This document contains proposed changes to clause 86. Deleted text is shown with ~~blue strikethrough~~. Added text is shown with red underline.

Figure 86–5—Data Dependent Pulse Width Shrinkage test method

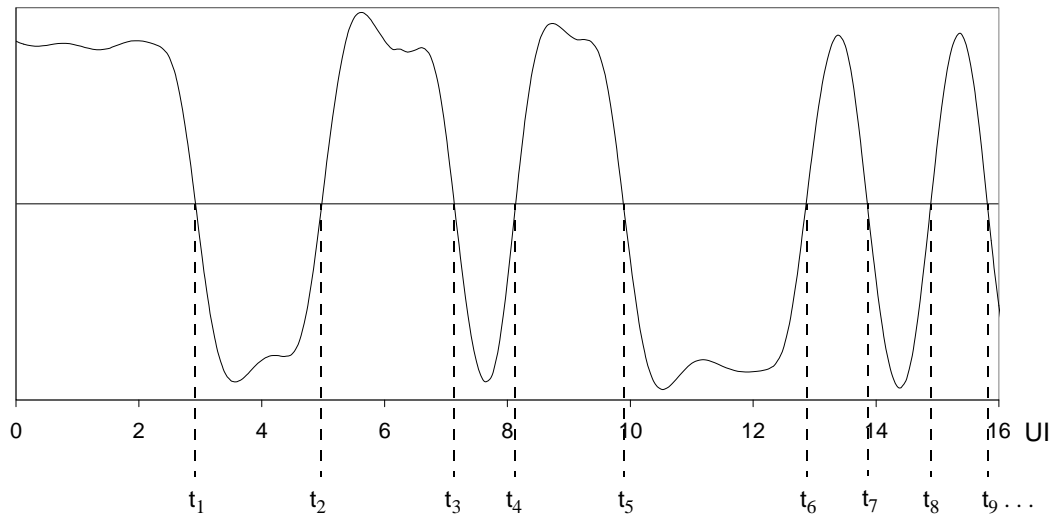
Replace clause 86.7.4.4 with the following:

86.7.4.4.1 Data Dependent Pulse Width Shrinkage (DDPWS)

An oscilloscope, time interval analyzer, or other instrument with equivalent capability may be used to measure DDPWS. A repeating PRBS9 pseudo-random test pattern, 511 bits long, is used. For electrical jitter measurements, the measurement bandwidth is 12 GHz. If the measurement bandwidth affects the result, it can be corrected for by post-processing. However, a bandwidth above 12 GHz is expected to have little effect on the results.

The crossing level is the average value of the entire waveform being measured. The instrument is synchronized to the pattern repetition frequency and the waveforms or the crossing times are averaged sufficiently to remove the effects of random jitter and noise in the system. The PRBS9 pattern has 128 positive-going transitions and 128 negative-going transitions. The crossing times t_1 to t_{256} of each transition of the averaged waveform (when the averaged waveform crosses the crossing level) are found as shown in Figure 86–5.

The DDPWS is the difference between one symbol period and the minimum of all the differences between pairs of adjacent transitions:

$$\text{DDPWS} = T - \min(t_2 - t_1, t_3 - t_2, \dots, t_{256+1} - t_{256}) \quad (86-1)$$

Where T is one symbol period.

Note that the difference from the next transition in the repeating sequence, t_{256+1} , is also considered.
